<b>Project Title:</b>	<b>Addendum No.:</b>
Stanley Knowles Fit-Up	2
<b>Project Location:</b>	<b>Project Number:</b>
391 York Avenue Winnipeg, MB	R.056754.002
<b>Consultant's Name</b>	<b>Date:</b>
Prairie Architects Inc.	January 15, 2014

**The following changes in the bid documents are effective immediately. The addendum will form part of the contract documents**

**MR-01**

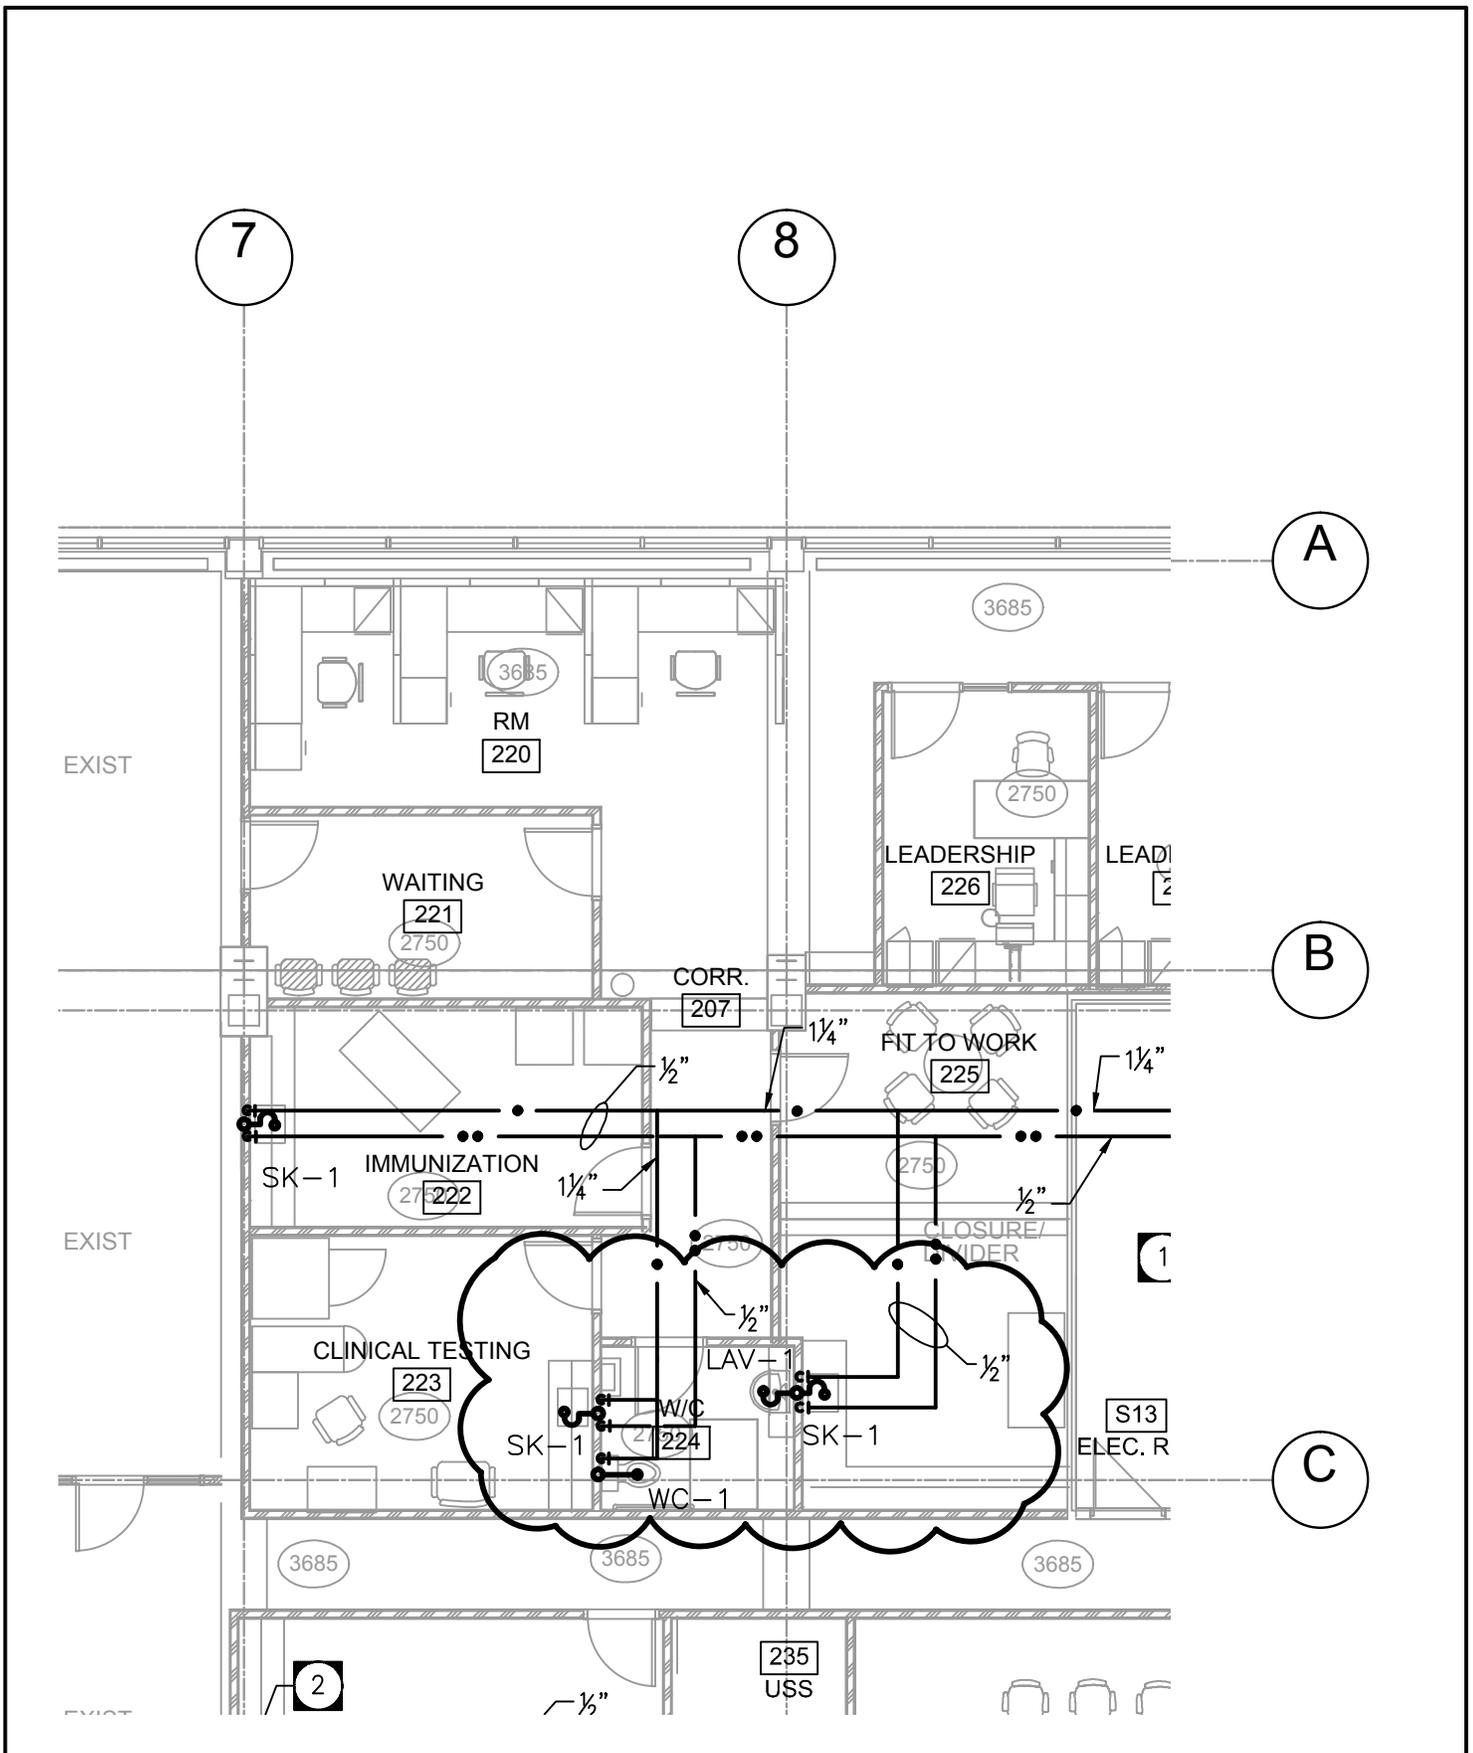
- 1.1 Drawing M1-02 Mechanical – Main Floor Plan - Plumbing
  - .1 Revised sanitary piping serving Washroom W/C 224 on above floor. Refer to attached Mechanical Revision sheet **MR-01**.
  - .2 Revise kitchen sink in Lunchroom 124 to SK-2.
  - .3 Provide ½" domestic cold water line below the counter from plumbing

**MR-02**

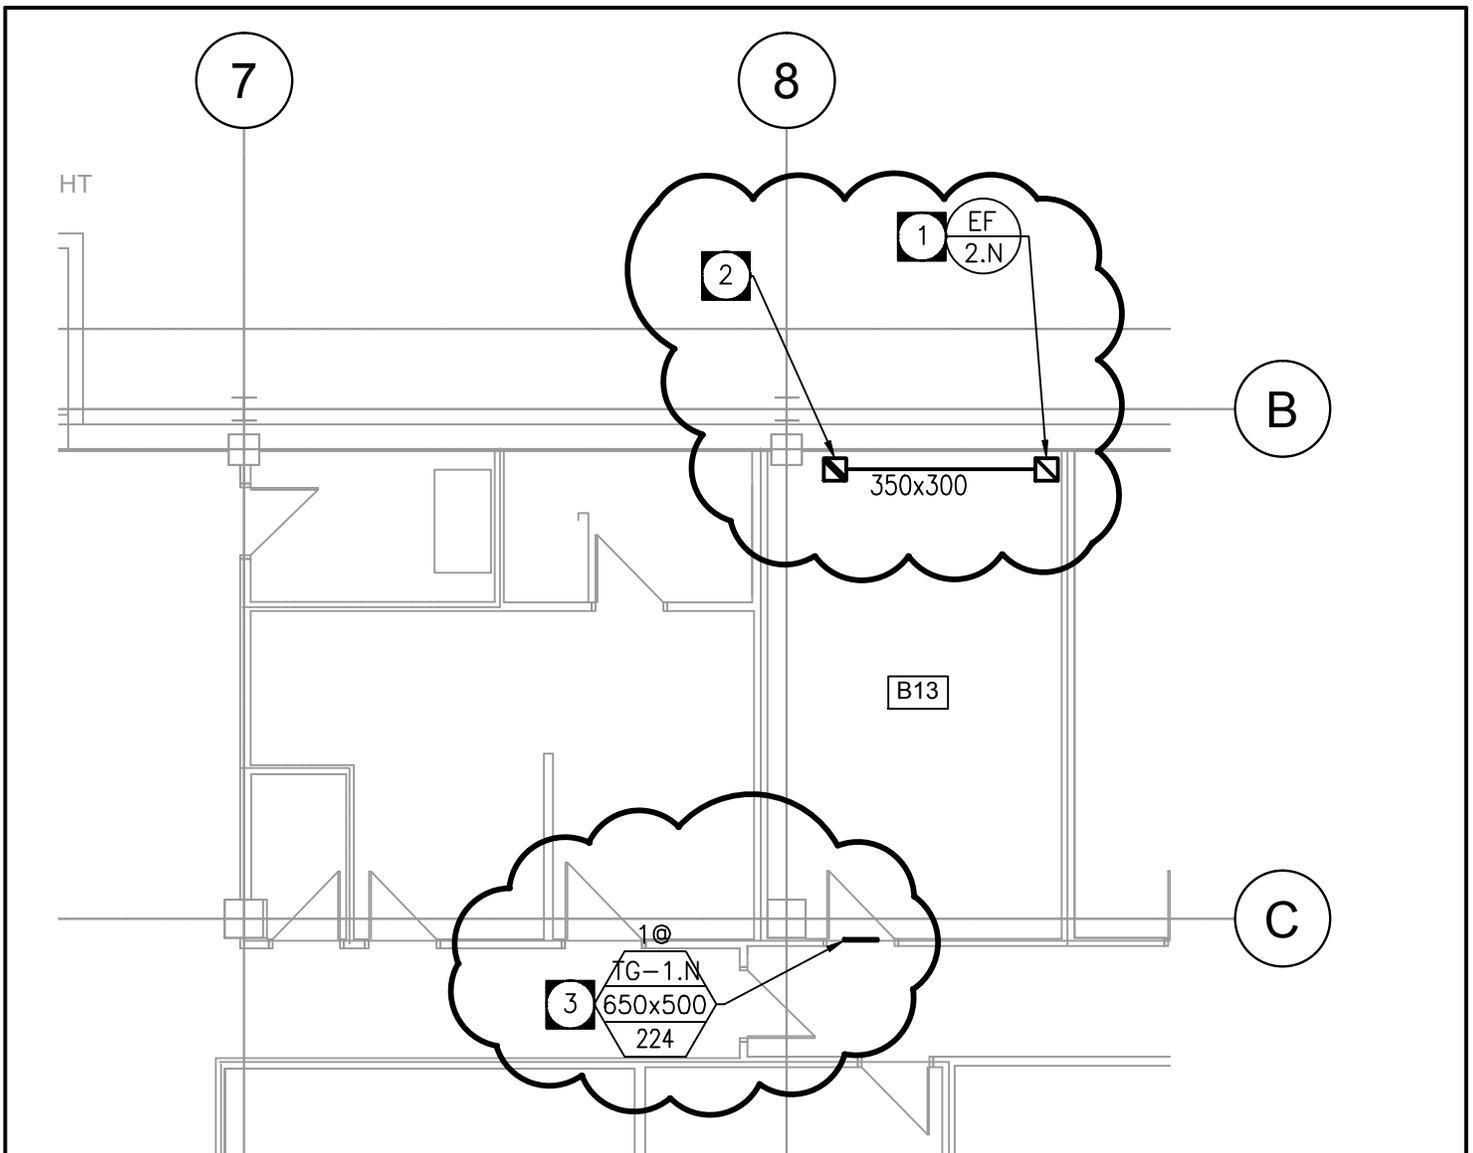
- 1.2 Drawing M1-03 Mechanical – Second Floor Plan - Plumbing
  - .1 Revised domestic cold water piping and domestic hot water piping serving Washroom W/C 224. Refer to attached Mechanical Revision sheet **MR-02**.

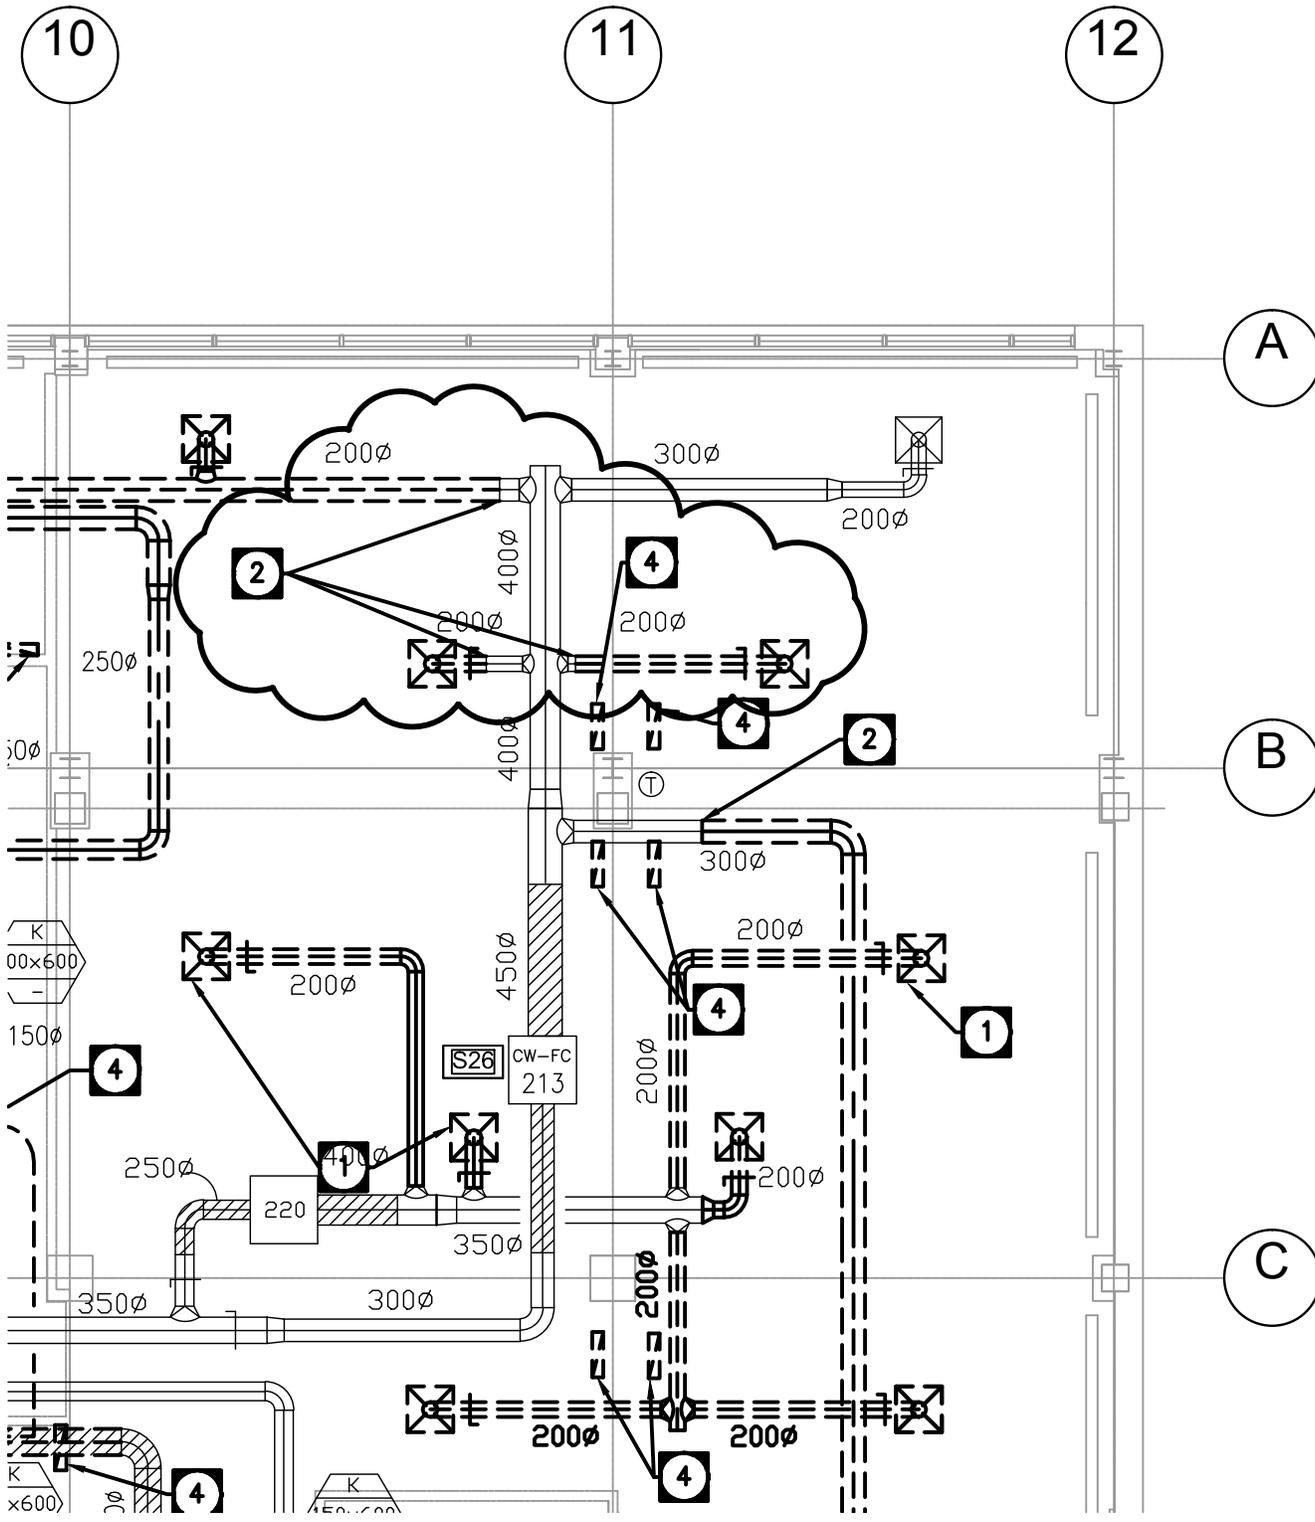
- 1.3 Drawing M2-01 Mechanical – Basement Floor Plan - HVAC
  - .1 Provide exhaust fan EF-2.N to serve Storage room B13. Duct exhaust up to main floor as shown. Provide fire damper at floor penetration. Refer to M2-04 for continuation.

- .2 Provide transfer grille TG-1.N as indicated in door of room Storage room B13.
  - .3 Refer to attached Mechanical Revision sheet **MR-03**.
- 1.4 Drawing M2-03 Mechanical – Partial 2nd Floor Plan – Demo HVAC

- 1 NEW HORIZONTAL DISCHARGE EXHAUST FAN TO SERVE ROOM B13.
- 2 EXHAUST DUCT UP TO MAIN FLOOR. REFER TO MAIN FLOOR FOR CONTINUATION. PROVIDE FIRE DAMPER AT FLOOR PENETRATION.
- 3 PROVIDE NEW TRANSFER GRILLE IN DOOR.

FILE: 13039 ADD 01  
 DATE: 14/01/14  
 DRAWING NO. / REVISION NO.  
**MR-04**

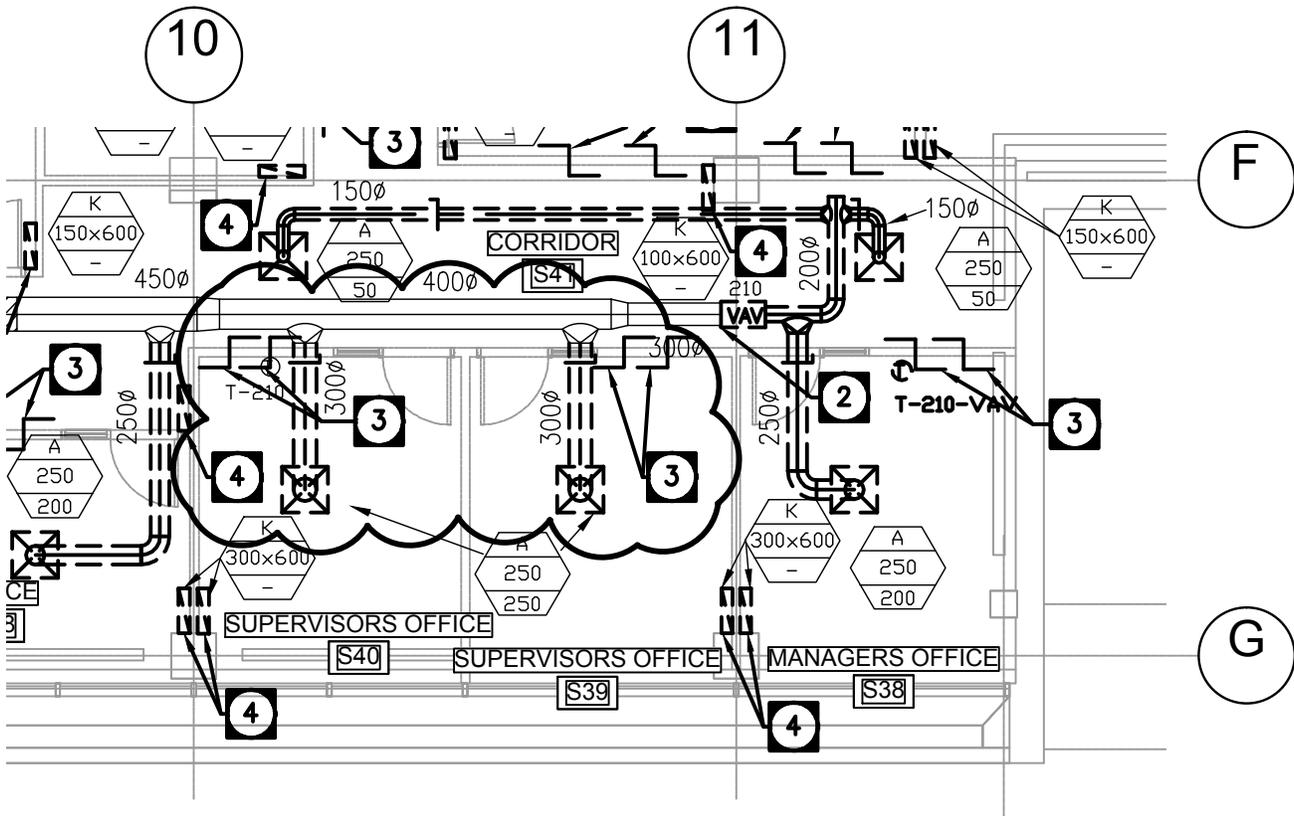
- .1 Provide additional ductwork demolition as indicated.
  - .2 Refer to attached Mechanical Revision sheet **MR-04 & MR-05**.
- 1.5 Drawing M2-04 Mechanical – Main Floor Plan – New HVAC

FILE: 13039 ADD 01  
 DATE: 14/01/14  
 DRAWING NO. / REVISION NO.  
**MR-06**

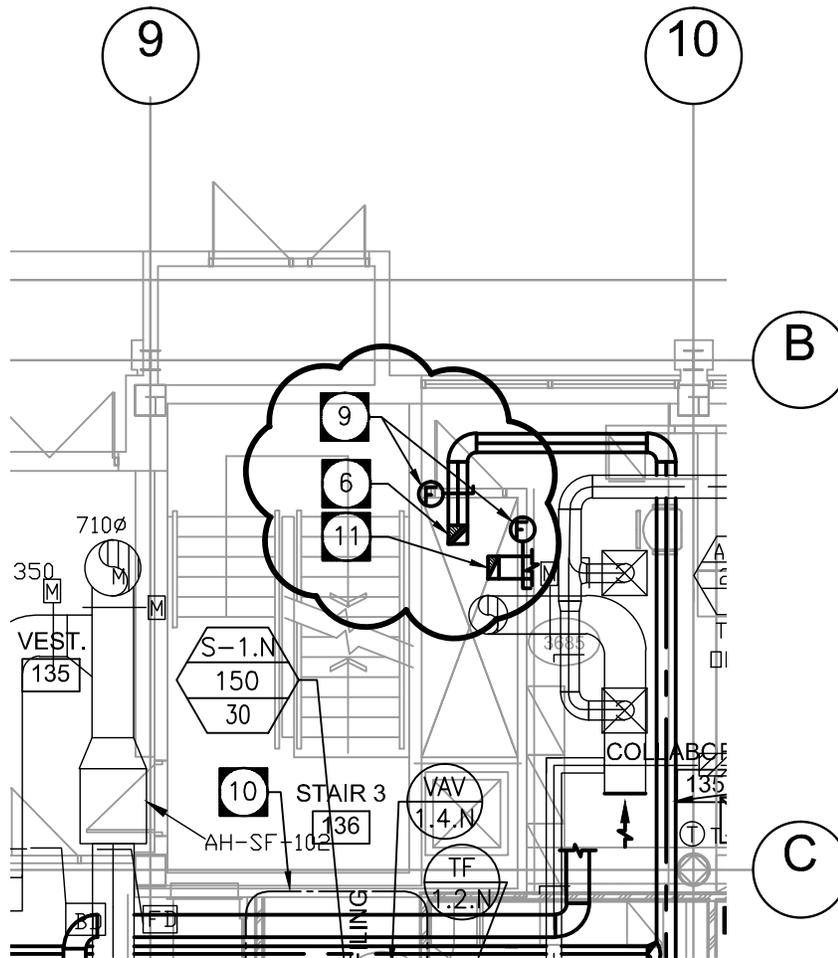
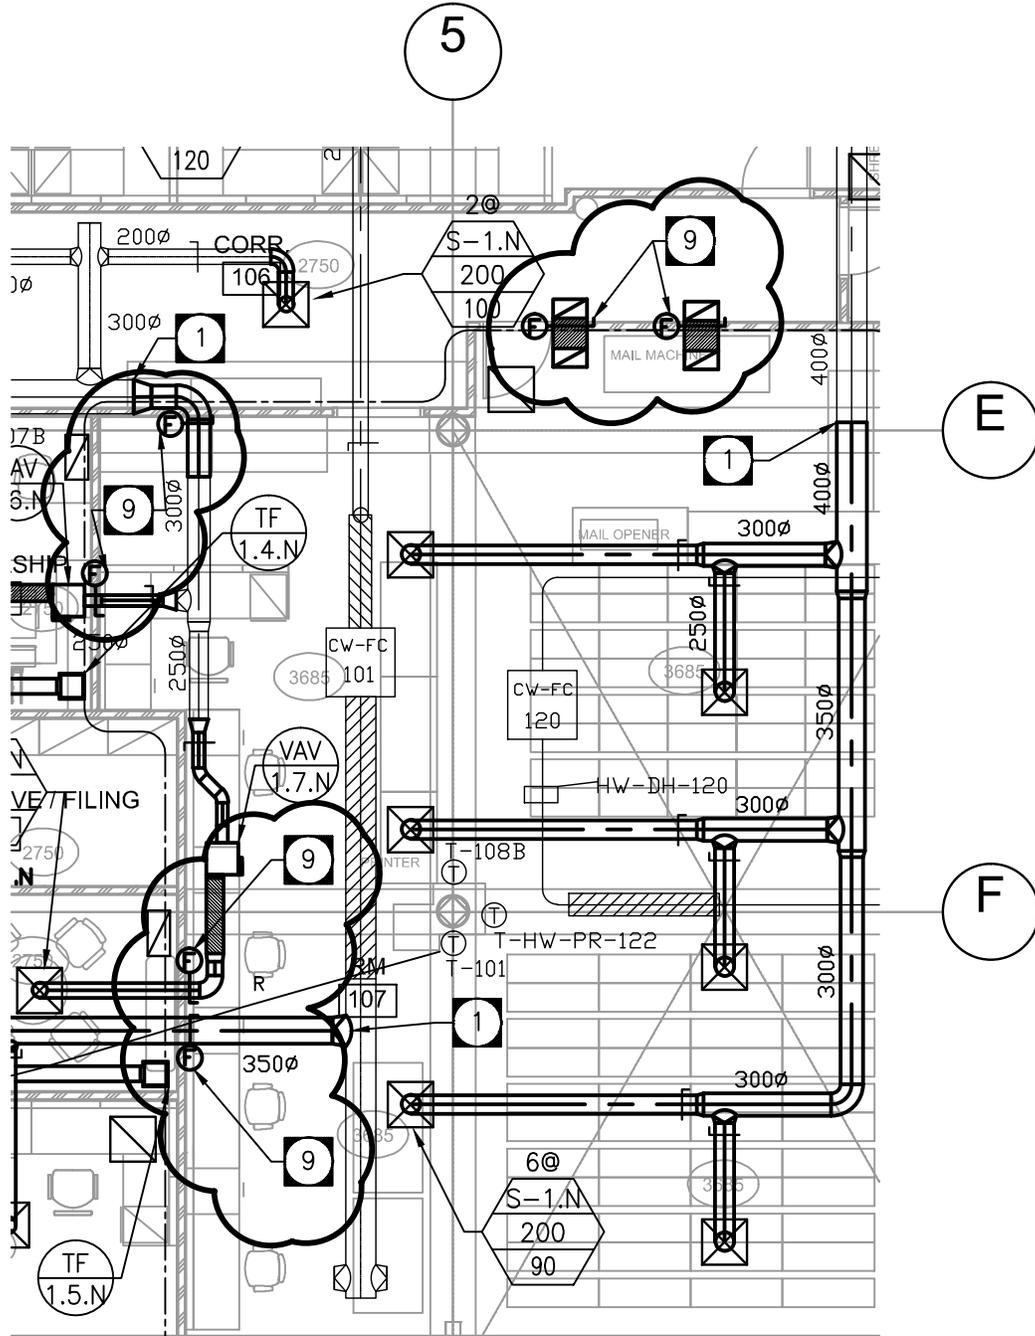
- .1 Provide new exhaust duct up from serving Storage room B13 below to ceiling level of main floor and out through exterior wall complete with aluminum hood and birdscreen. Refer to attached Mechanical Revision sheet **MR-06**.
